TROWBRIDGE & WOLF
Landscape Architects Planners

August 21, 2002

**WEST CAMPUS RESIDENTIAL INITIATIVE DEIS
ADDENDUM THREE**

Figure 2.11.A (Adden.):
 Community Character

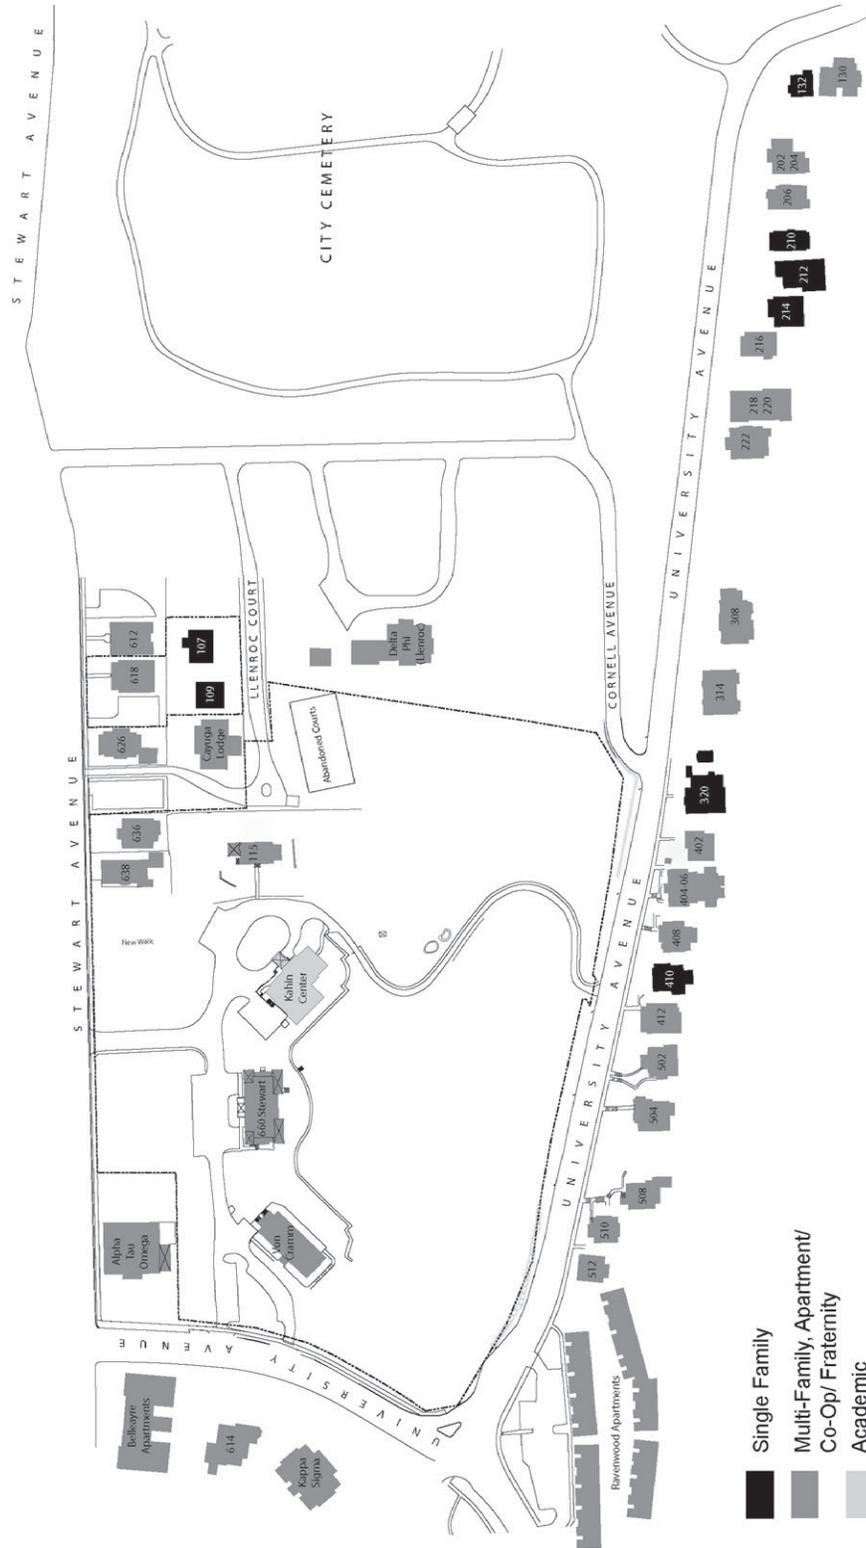
1. **Replace** pages 121-a, 121-b and 121-c Section 2.11 Community Character at University Avenue Parking Lot, **Addendum 2**, and Figure 2.11A Community Character with the attached **Revised** Section 2.11 and **Revised** Figure 2.11, **Addendum 3**, dated August 22, 2002. (pages 121-a, 121-b, 121-c and 121-d)
2. **Chapter Four**, Section 4.2 Alternatives to University Avenue Surface Parking, 4.2.:
ADD the attached pages 147-a, 147-b, and 147-c, **4.2.5 Parking distributed on Multiple Sites**, to the end of the section
3. Proposed City of Ithaca Water Tank at the Site of the Proposed University Avenue Parking Lot:
ADD the attached section, including Appendix to Addendum Three, to the back of the WCRI DEIS.
